MEMORANDUM

TO: District of Columbia Zoning Commission

SUBJECT: Hearing Report ZC 09-03F – Modification of Significance for ZC Order 09-03, 09-03A to 09-03E, for Skyland Town Center

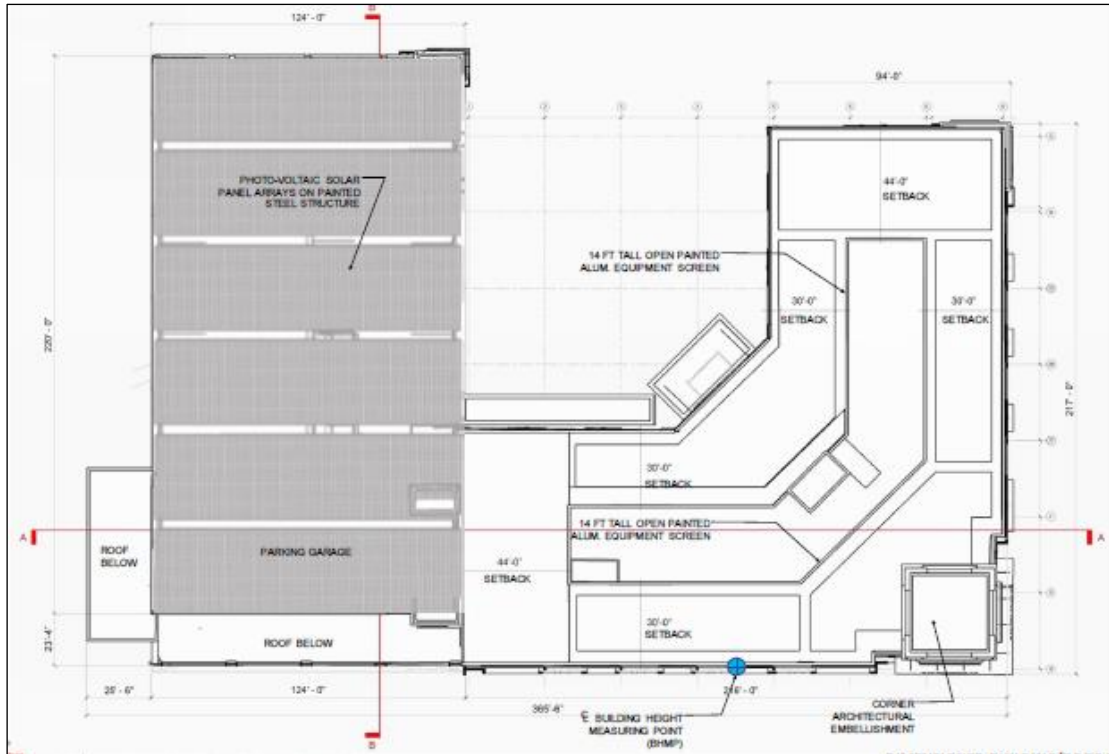
The garage would have a similar architectural style and materials as the office building. Along Naylor Road, the upper four levels of the garage would be set back approximately 24 feet from the front of the building on the first floor Exhibit 22C3, page A204. The setback allows that cars within the garage would not be visible from Naylor Road (Exhibit 22C3, pages A216, A217, A219). The ground level of the garage facing Naylor Road would be lined with utility rooms and although the façade pattern would be similar to the office building, openings would be blocked off with no views to the interior through the use of shadow boxes.

These shadow boxes create an opportunity to feature local artists, showcase community arts programs and events, and provide information to visitors to the Town Center, as well as an attractive feature along Naylor Road for pedestrians to enjoy. The Applicant has partnership with Building Bridges Across the River and the Town Hall Education Arts & Recreation Campus (THEARC) (Exhibit 22A) to curate and manage a rotating installation of artwork, community notices and information and create opportunities to feature the works of local artist. THEARC currently has partnership with Phillips Collection, the Washington School for Girls, and Bishop Walker School for Boys and other organization.

This condition should be revised to indicate the shadow boxes on the medical building; garage shall not be eliminated and should be maintained.

Screening

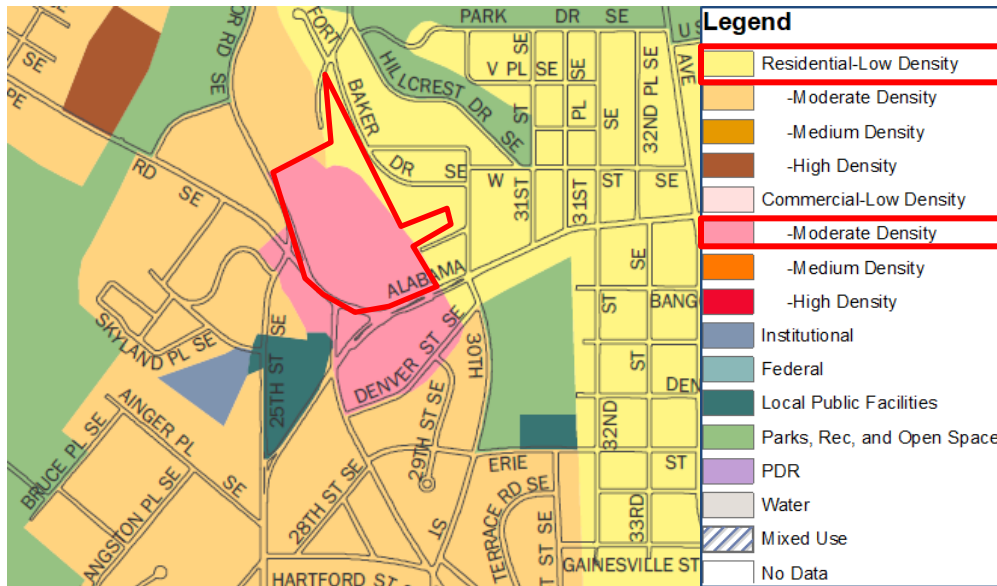
As part of former approvals, screening the development, especially parking garages or parking lots from the Hillcrest, single family residences to the northeast of the property, was a very important aspect of the development. The property is separated from the residences by a ravine and sits at a slightly higher elevation than the residences. In former approvals, screening was provided by a combination of green screens, retaining walls and landscaping. In this proposal, the parking garage for the medical building would be further away from the residences. Retaining walls would still be used but would be shorter with a more gradual slope. The surface parking lot adjacent to the ravine, which was formerly proposed on new Block 4, would be replaced with a residential building and open space. On Block 3, the supermarket loading area and the parking lot would be separated by a wall and additional landscaping. Comparisons of the approved screening and that proposed in this development are at Exhibit 22C2, pages A105b to A105f and Exhibit 22C3, page A120g.
